Detailed Site Plan DSP-98039-04
Departure from Sign Design Standards DSDS-25001
Maryland 95 Corporate Park, Redevelopment of Lot 20

STAFF REPORT

SUBJECT: Detailed Site Plan DSP-98039-04
Departure from Sign Design Standards DSDS-25001
Type 2 Tree Conservation Plan TCP2-2025-0071
Maryland 95 Corporate Park, Redevelopment of Lot 20

Figure 5: Site Cross-Section Exhibit

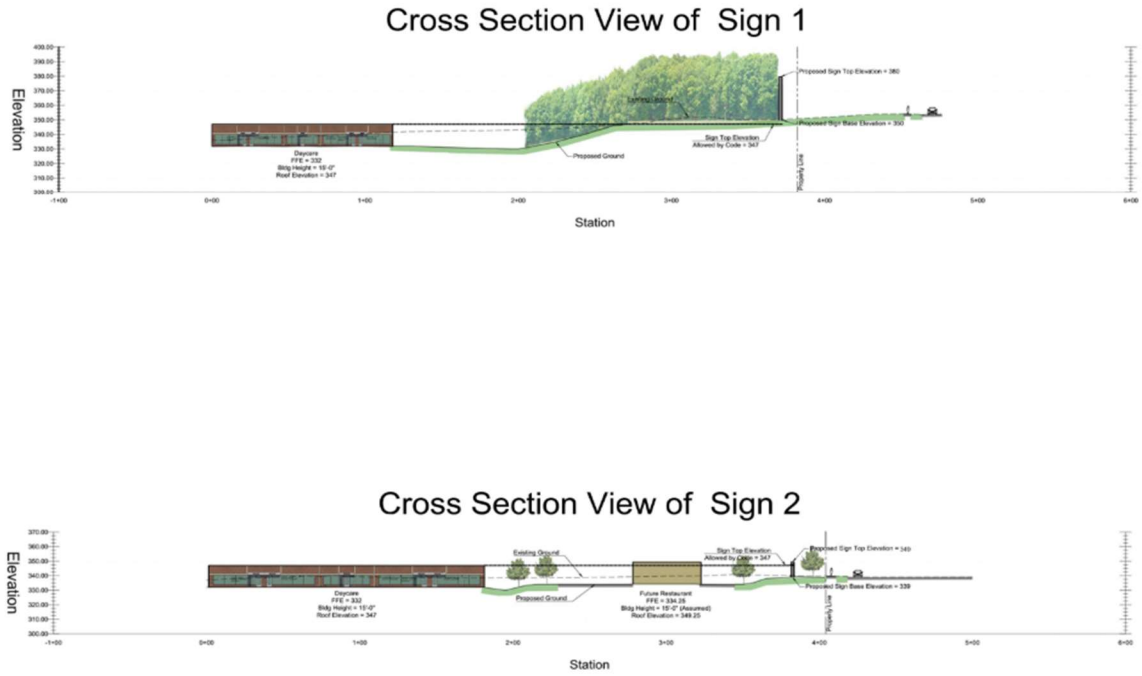
The applicant further asserts that the proposed 30-foot height of the Konterra Drive sign represents the minimum necessary to ensure adequate visibility and legibility of the sign, with the 40 mile per hour speed limit on Konterra Drive, distance of the sign from the roadway, and the existing tall vegetation to remain around the sign. Though Lot 22 does not actually abut Konterra Drive, due to the adjacent lot configuration, the applicant takes into consideration the "perceived" frontage, from both Sweitzer Lane and Konterra Drive. This perceived frontage takes into account the frontage along Sweitzer Lane and Konterra Drive, if not for the abutting lots which form a narrow strip of land between Lots 22 and the ROW. The site's topography creates a circumstance in which the elevation at the intersection of Sweitzer Lane and Konterra Drive is higher than the existing and proposed buildings, impeding upon the awareness and identification of the development from the intersection and, as the applicant believes, contributes to the vacancy of the existing office building in the development. Staff find that provided signage that departs from the standards represents the minimum necessary, given the specific circumstances of the request.

CIRCULATION EXHIBIT

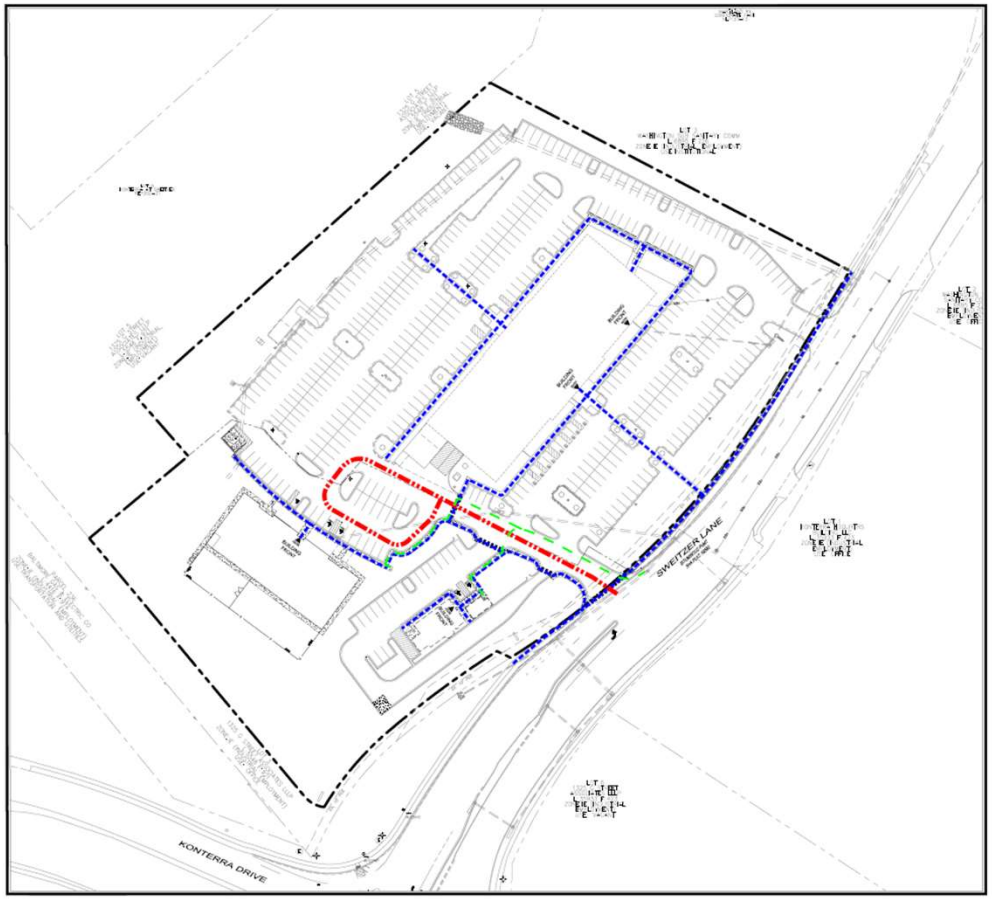
Three, 12 feet by 33 feet loading spaces are located on-site. One space is proposed at the rear of the drive-through establishment on the southern portion of the site, while the remaining two spaces are existing and located along the southwest side of the office building. A circulation exhibit was provided, demonstrating the movements of a dump truck throughout the site. However, a circulation plan demonstrating how large delivery and emergency vehicles will circulate through the site is required to confirm sufficient circulation is provided, and a condition has been included accordingly.

In addition, the circulation plan demonstrates the movements of bicyclists and pedestrians throughout the entire site. The site proposes sidewalks along the internal drive aisle and along the perimeter of the buildings including marked crosswalks for connections to the proposed and existing uses. Staff find circulation to be acceptable.

l. Provide a circulation plan demonstrating sufficient circulation for large delivery and emergency vehicles.
